**DELAWARE ARMY NATIONAL GUARD
PIGMAN READINESS CENTER – ADA UPGRADES
SEAFORD, DELAWARE
DBF #0999J013.B01
September 17, 2015**

ADDENDUM NO. 3

SK-2

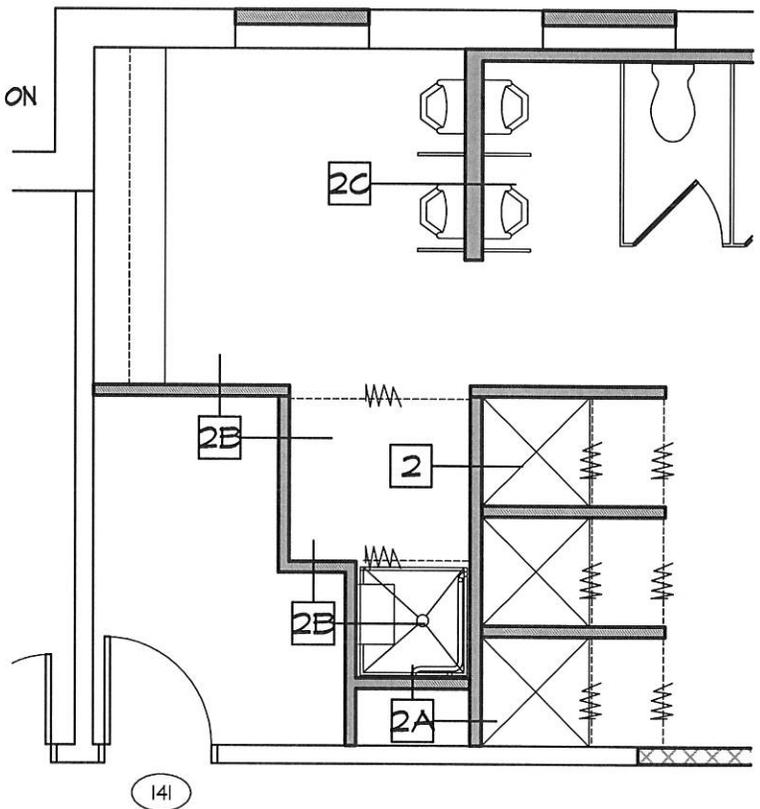
- Item No. 5 Wall types 2B and 2C were added, refer to attached Sketch SK-2.
- Item No. 6 The floor finish and base in the closet adjacent to the new Men's shall be epoxy and existing CMU walls shall be epoxy painted.

FINISHES ON ONE SIDE ONLY

CERAMIC WALL TILE & CEMENT BD. ON TOILET ROOM SIDE

6" STUDS
